Access Compliance Report

Public Rights-of-Way

Intersection ID: 6217	Main Street: BACK_CREEK_CHURCH_RD	Cross Street: WYNDHAM_POINTE_DR	Location: NW
ADA ID: 04334D81CA0E	Ramp Type: Perp	Initial Pass/Fail: Fail	Overall Compliance: No
Codes/Mitigation Info/Possible Solution			Severity Score: 25
			Field Measurements/Component Compliance

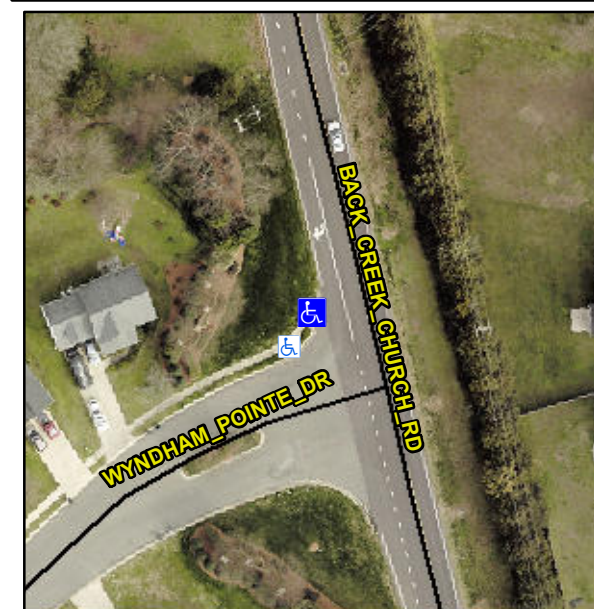
Not Found, R304.2.2, R304.5.3

Compliance	Description	Data	Compliance	Description	Data
N/A	Ramp Length (in)	47.0	No	Ramp Slope (%)	9.9
Yes	Ramp Width (in)	50.0	No	Ramp XSlope (%)	5.3
N/A	Flare Type LT	N/A	N/A	Flare Type RT	N/A
N/A	Flare Slope LT (%)	N/A	N/A	Flare Slope RT (%)	N/A
N/A	Flare Traversable LT?	N/A	N/A	Flare Traversable RT?	N/A
N/A	Landing Length (in)	N/A	N/A	DWS Provided?	N/A
N/A	Landing Width (in)	N/A	N/A	DWS Contrast?	N/A
N/A	Landing Slope (%)	N/A	N/A	DWS Length (in)	N/A
N/A	Landing X Slope (%)	N/A	N/A	DWS Full Width?	N/A
N/A	Landing Curb? (Y/N)	N/A	N/A	DWS Offset (in)	N/A
N/A	Shared Landing?	N/A			
N/A	Gutter Ponding?	N/A	N/A	Gutter Slope (%)	N/A
N/A	Gutter Lip Ht (in)	N/A	N/A	Gutter X Slope (%)	N/A
N/A	Painted X Walk1?	No	N/A	Painted X Walk2?	N/A
	X Walk 1 Direction	To E		X Walk 2 Direction	N/A
N/A	X Walk 1 Width (in)	N/A	N/A	X Walk 2 Width (in)	N/A
	X Walk 1 Slope (%)	7.3		X Walk 2 Slope (%)	N/A
	X Walk 1 X Slope (%)	5.4		X Walk 2 X Slope (%)	N/A

Remove & Replace Entire Ramp.
